July 7, 2023

Subject: **Commerce Roof Replacement - Addendum 1**
Commerce Service Center
600 S. Elm Street
Commerce, Georgia
PM&A Project No. 23-019

Addendum Summary

This addendum modifies existing parapet details, adds additional scope at HVAC unit, modifies the material staging locations, answers Contractor's question, replaces the standard warranty, and provides the Pre-bid sign in sheet.

A1.1

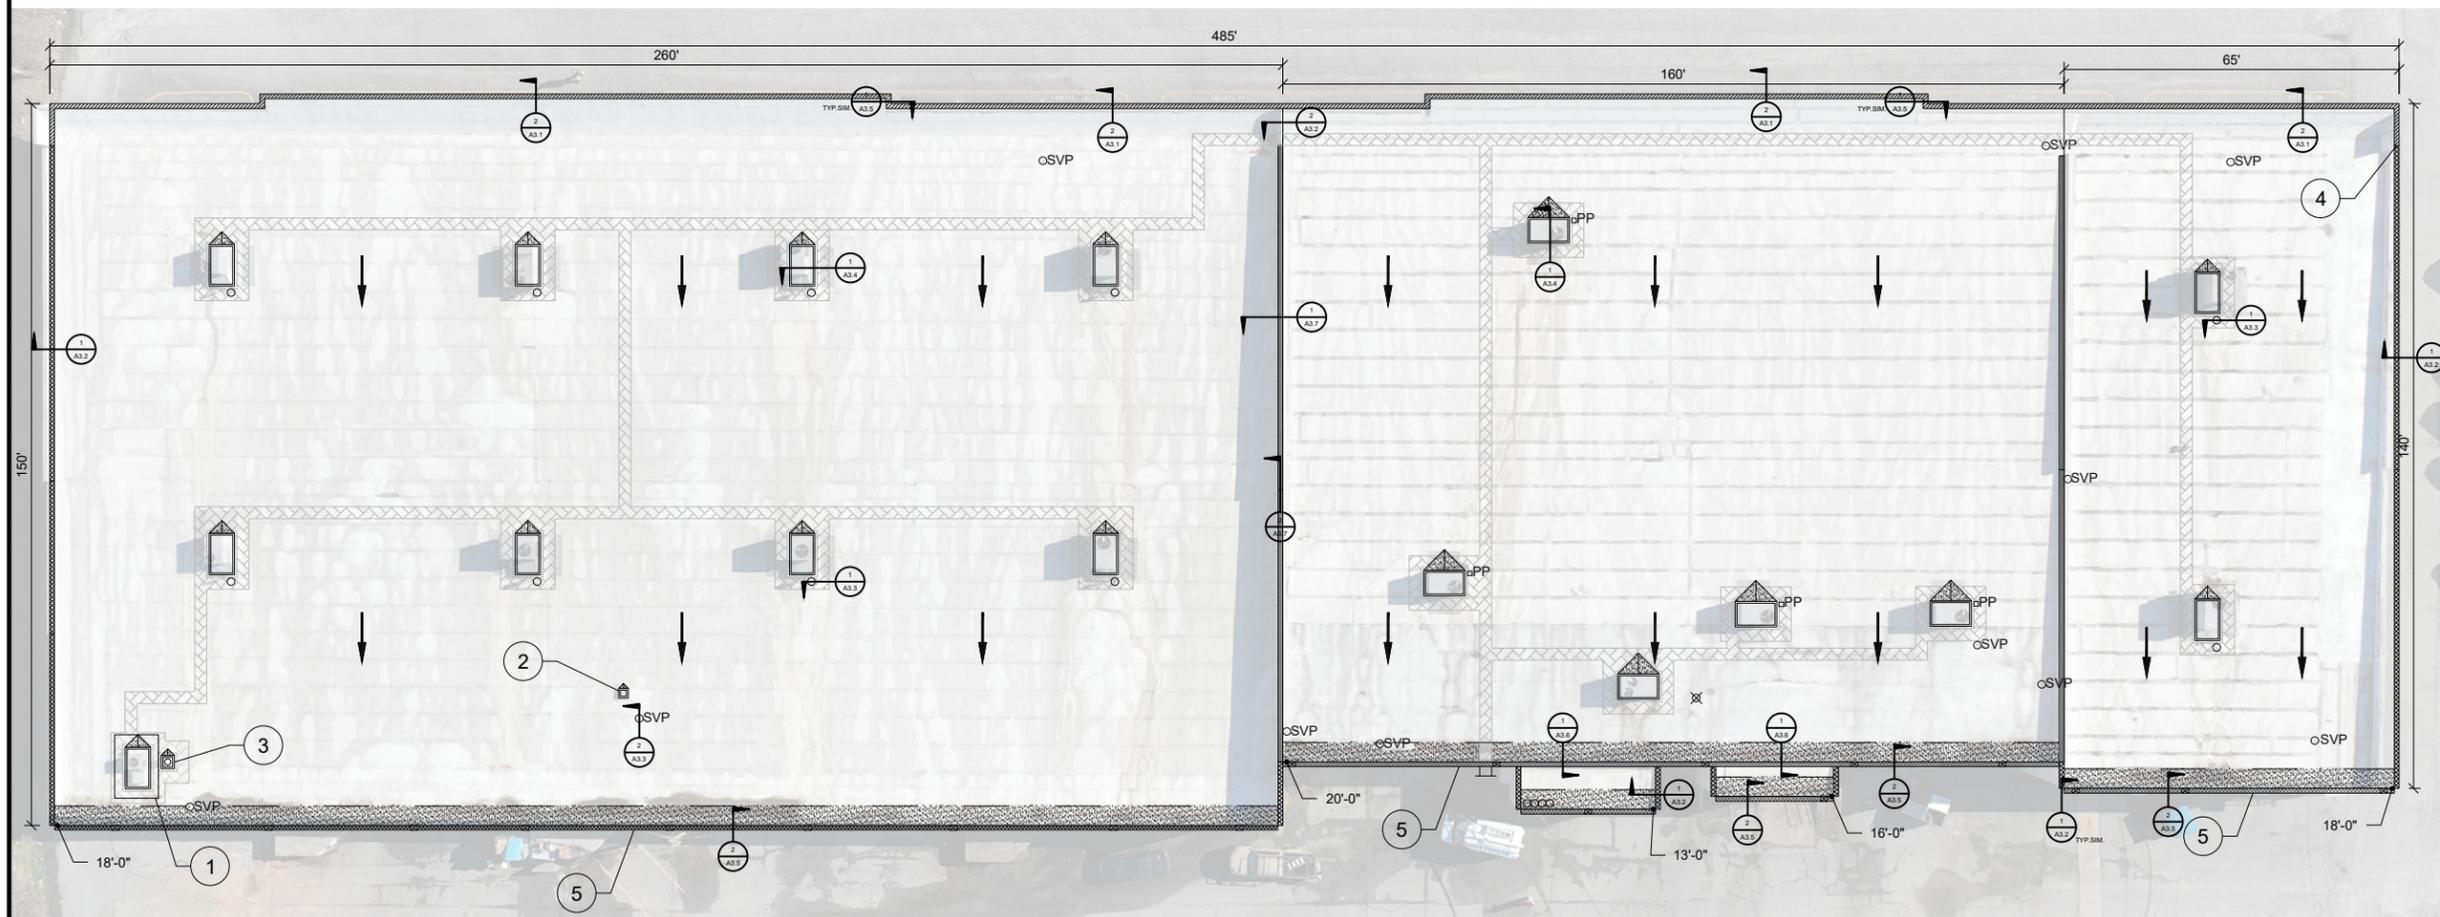
15. At the unit shown on plans, raise the unit and replace the existing unit curb. Furnish and install new curbs for the unit and duct penetration. This may require after-hours work.

1. UNIT TO BE RAISED AND NEW CURB INSTALLED.
2. TYPICAL ABANDONED CURB TO BE WRAPPED WITH COVERBOARD AND MEMBRANE
3. TYPICAL CURB TO BE RAISED TO 8" FLASHING HEIGHT
4. VERTICAL 5X5 TPO COATED METAL TO MATCH ADJACENT EDGE METAL
5. GUTTERS REQUIRING EXPANSION JOINTS

E. At the unit and duct shown on plans, raise the existing unit as required to replace the curb.

1. All electrical and HVAC connections and extensions shall be performed by an electrician licensed in the state of Georgia for a minimum of 5-years.
2. Provide necessary interior protections and coordination with the tenants.
3. Completely remove the existing curb.
4. Furnish and install new curb. Secure the curb to the deck using the specified #12 screw at 12-inches on center.
5. Flash the curb in accordance with manufacturer requirements.

DETAIL TYPICAL PARAPET FASCIA
 SCALE: NTS
 1
A3.2

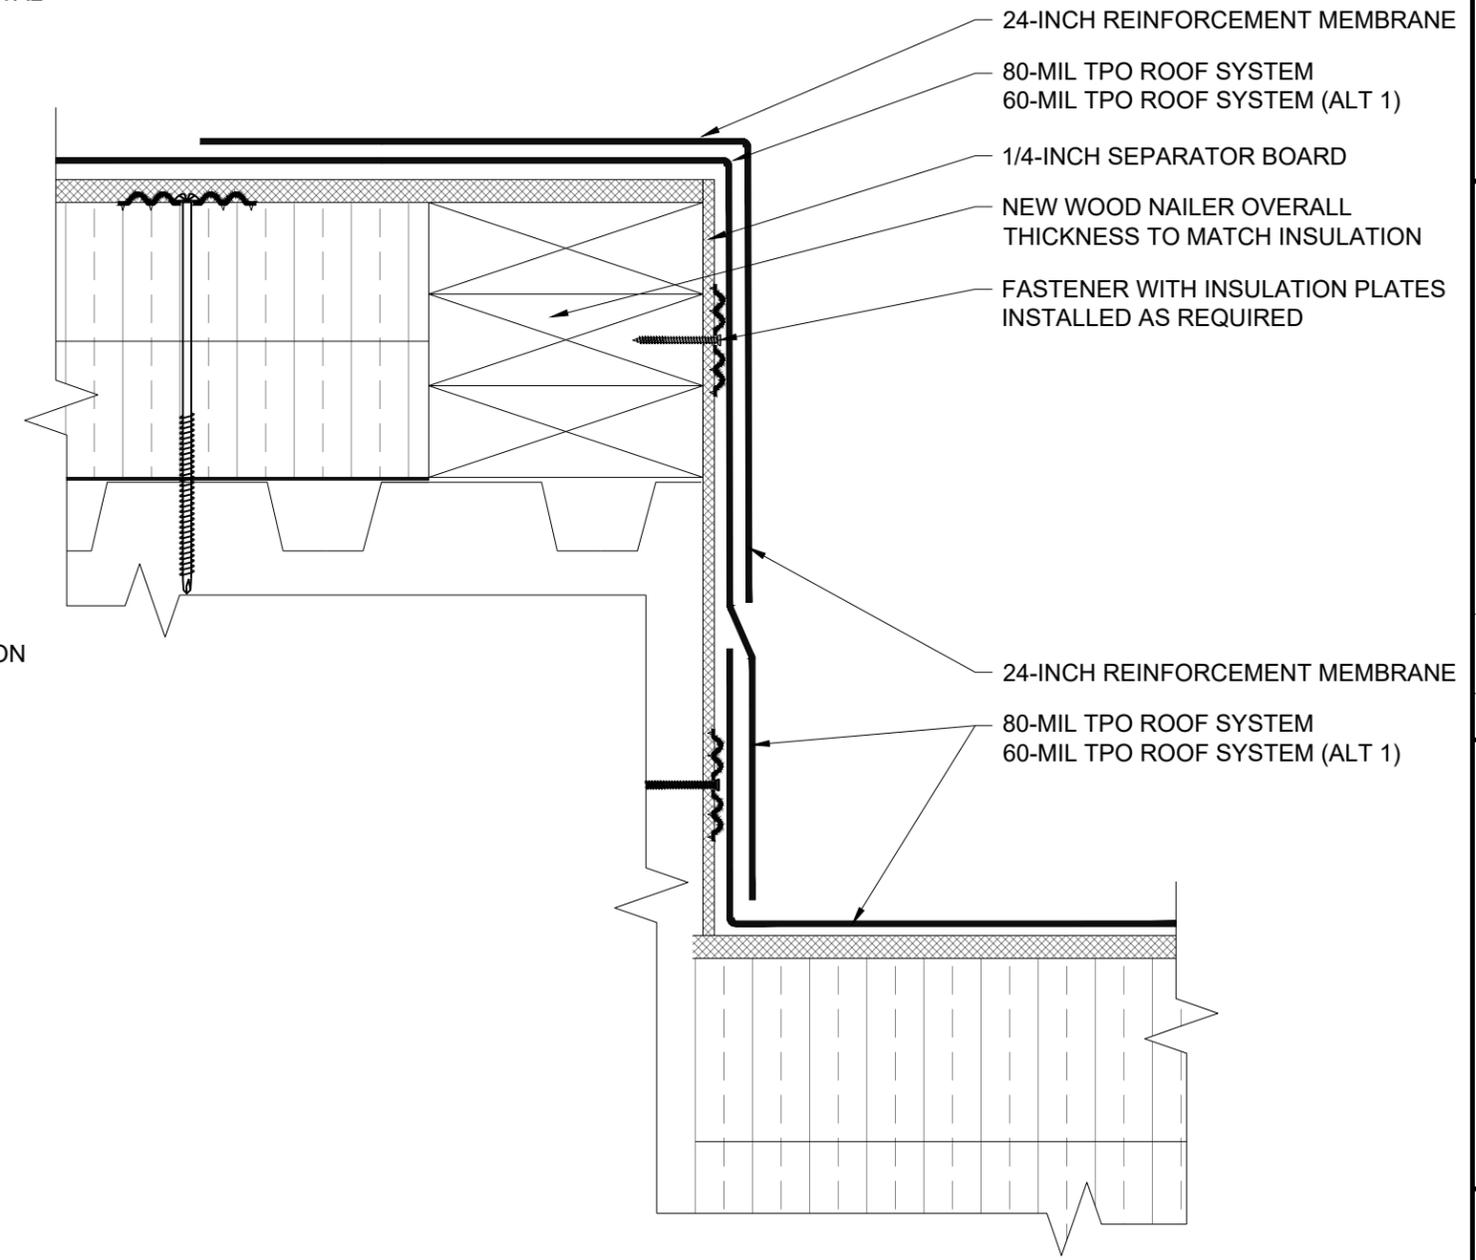
- B. Section 06 10 53 Miscellaneous Rough Carpentry; replace Section 3.02.B. with the following:
B. Furnish and install new continuous tapered wood blocking on top of the existing parapet as shown in the drawings. Secure the wood blocking to the existing structure using specified screws at 12-inches on center, staggered pattern. Taper shall provide a minimum slope of ¼-inch-per-foot across the parapet. Refer to Drawings.
